Subject: Limerick Generating Station, Unit 1  
Technical Specifications Change Request No. 00-02-1  
Changes to Reactor Pressure Vessel Pressure-Temperature Limits

**TECHNICAL SPECIFICATIONS CHANGE REQUEST  
NO. 00-02-1**

**"Changes to Reactor Pressure Vessel Pressure-Temperature Limits"**

MINIMUM REACTOR VESSEL METAL TEMPERATURE VS. REACTOR VESSEL PRESSURE  
 FIGURE 3.4.6.1-1

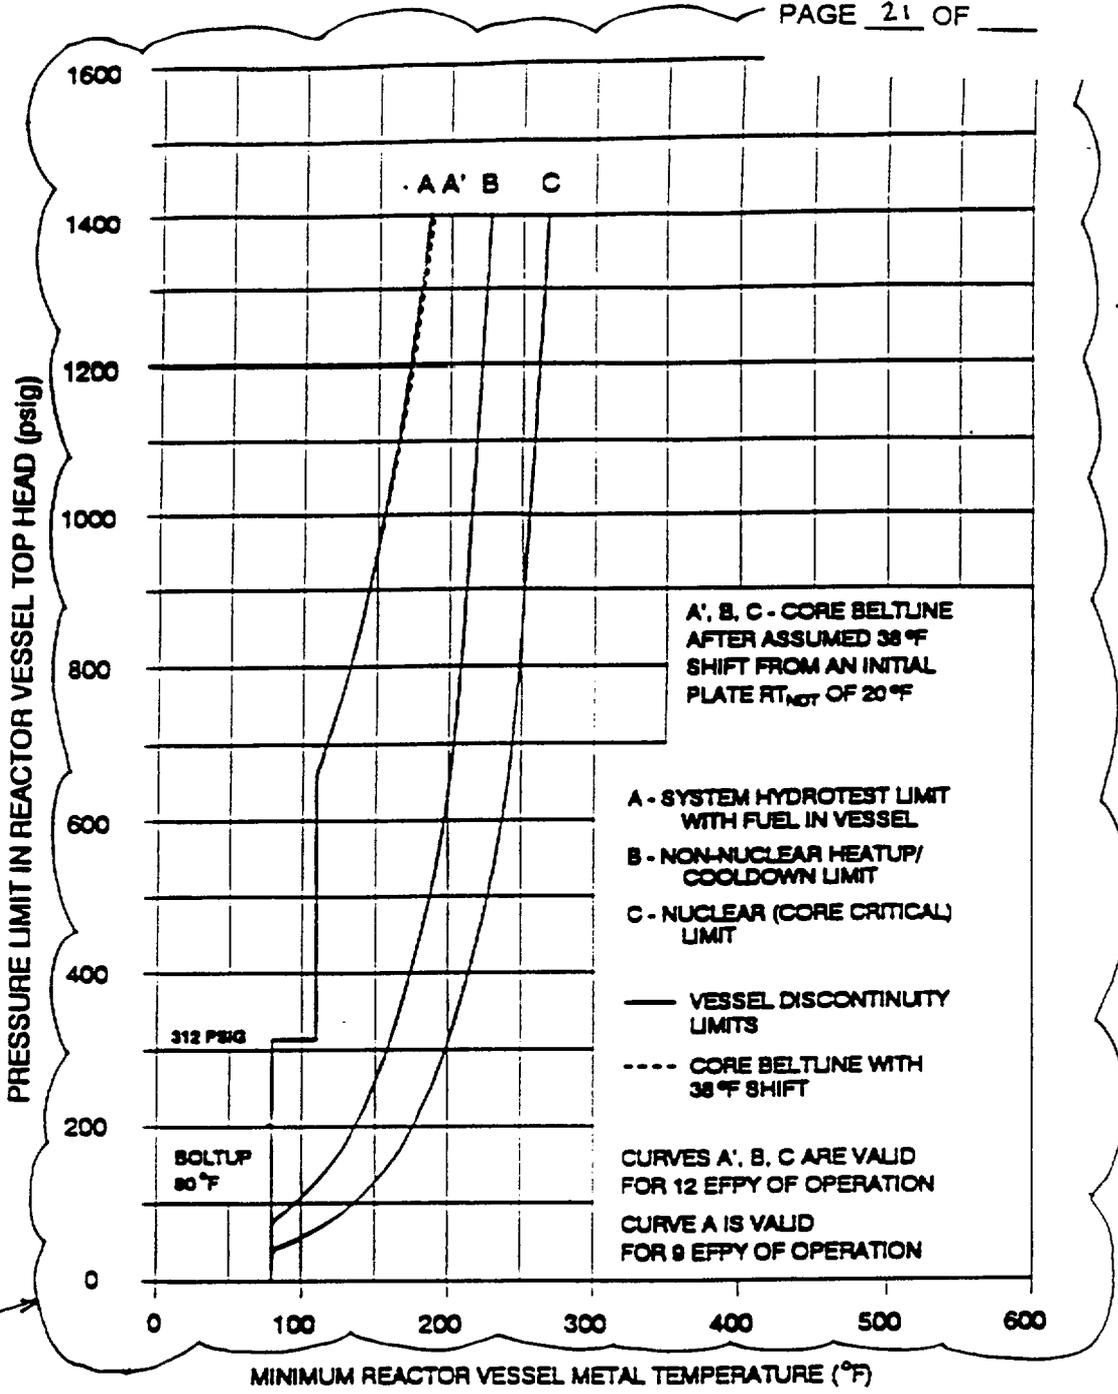
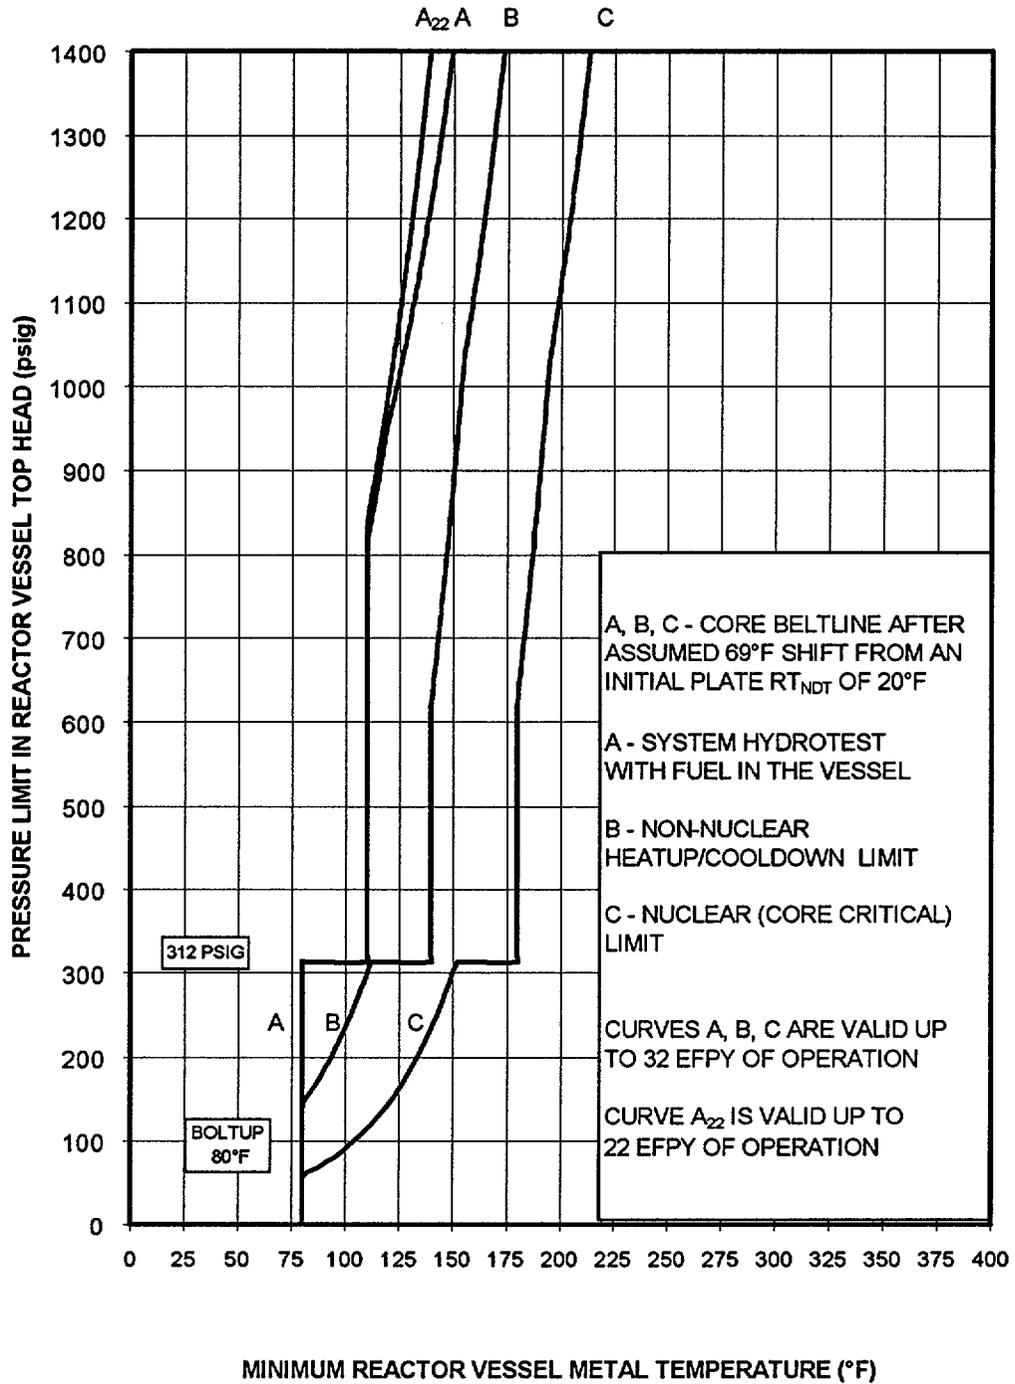
3.4.6.1 The reactor coolant system temperature and pressure shall be limited in accordance with the limit lines shown on Figure 3.4.6.1-1 (1) curve A ~~and A'~~ for <sup>DELETE</sup> hydrostatic or leak testing; (2) curve B for heatup by non-nuclear means, cool-down following a nuclear shutdown and low power PHYSICS TESTS; and (3) curve C for operations with a critical core other than low power PHYSICS TESTS, with:

4.4.6.1.1 During system heatup, cooldown and inservice leak and hydrostatic testing operations, the reactor coolant system temperature and pressure shall be determined to be within the above required heatup and cooldown limits and to the right of the limit lines of Figure 3.4.6.1-1 curve A ~~and A'~~, B, or C as applicable, at least once per 30 minutes.

DELETE

REVISE AS SHOWN ON ATTACHMENT

The reactor vessel materials have been tested to determine their initial RT<sub>NDT</sub>. The results of these tests are shown in Table B 3/4.4.6-1. Reactor operation and resultant fast neutron, E greater than 1 MeV, irradiation will cause an increase in the RT<sub>NDT</sub>. Therefore, an adjusted reference temperature, based upon the fluence, nickel content and copper content of the material in question, can be predicted using Basas Figure B 3/4.4.6-1 and the recommendations of Regulatory Guide 1.99, Revision 2, "Radiation Embrittlement of Reactor Vessel Materials." The pressure/temperature limit curves, Figure 3.4.6.1-1, curve A includes a shift in RT<sub>NDT</sub> for conditions at 8 EFPY. The A<sup>0</sup>, B and C limit curves are predicted to be bounding for all areas of the RPV until 12 EFPY, when the beltline material's RT<sub>NDT</sub> will shift due to neutron fluence and the beltline curves will intersect the non-beltline discontinuity curves. IN ADDITION, AN INTERMEDIATE A CURVE HAS BEEN PROVIDED FOR 22 EFPY. DELETE

3.4.6.1 The reactor coolant system temperature and pressure shall be limited in accordance with the limit lines shown on Figure 3.4.6.1-1 (1) curve A for hydrostatic or leak testing; (2) curve B for heatup by non-nuclear means, cool-down following a nuclear shutdown and low power PHYSICS TESTS; and (3) curve C for operations with a critical core other than low power PHYSICS TESTS, with:

4.4.6.1.1 During system heatup, cooldown and inservice leak and hydrostatic testing operations, the reactor coolant system temperature and pressure shall be determined to be within the above required heatup and cooldown limits and to the right of the limit lines of Figure 3.4.6.1-1 curve A, B, or C as applicable, at least once per 30 minutes.

The reactor vessel materials have been tested to determine their initial  $RT_{NDT}$ . The results of these tests are shown in Table B 3/4.4.6-1. Reactor operation and resultant fast neutron, E greater than 1 MeV, irradiation will cause an increase in the  $RT_{NDT}$ . Therefore, an adjusted reference temperature, based upon the fluence, nickel content and copper content of the material in question, can be predicted using Bases Figure B 3/4.4.6-1 and the recommendations of Regulatory Guide 1.99, Revision 2, "Radiation Embrittlement of Reactor Vessel Materials." The pressure/temperature limit curves, Figure 3.4.6.1-1, include a shift in  $RT_{NDT}$  for conditions at 32 EFPY. The A, B and C limit curves are predicted to be bounding for all areas of the RPV until 32 EFPY. In addition, an intermediate A curve has been provided for 22 EFPY.
